**2 Type of change**

Product Change Notification						PCN FMW-55 FSS-55 case 10 redesign	
owner	creation date	release date	released by	change order no	rev	page	D10-041-503
segatro	04.12.2019	10.12.2019	canoniar	2018652	A	1 of 2

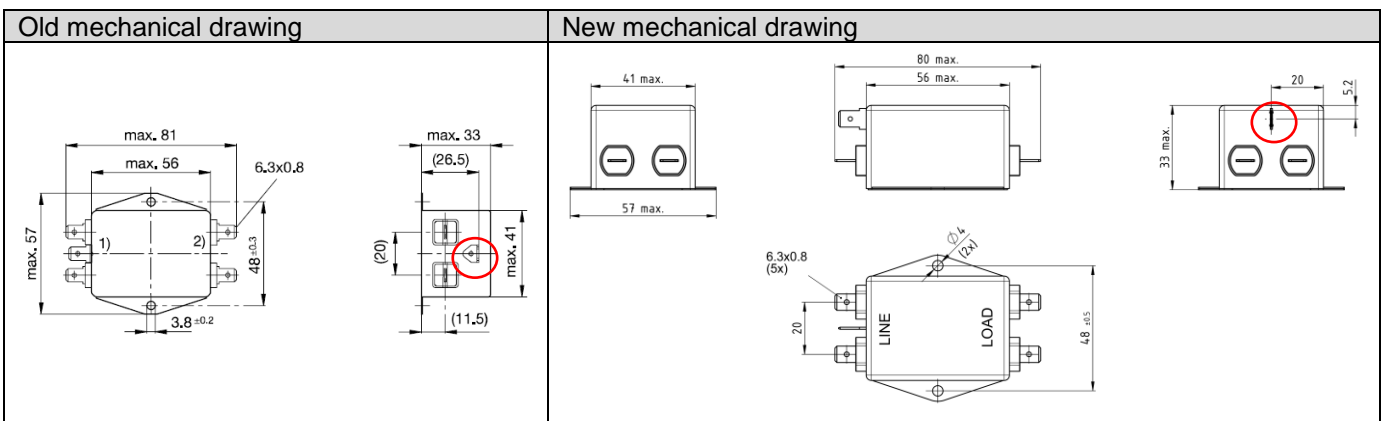
- Nickel plated steel case instead of aluminium case
- Different shape of external quick connect terminals
- Change of production site

- Change of product appearance due to new nickel plated steel case instead of aluminium case
- Different shape of plastic part for external quick connector terminals
- Moved position and turned protective earth terminal to a vertical position
- Change of factory code from SK to SC and origin from SK to CN on product and packaging labels

- Improved filter performance due to completed closed steel case
- Reorganization of production process
- Production site transfer from Slovakia to China
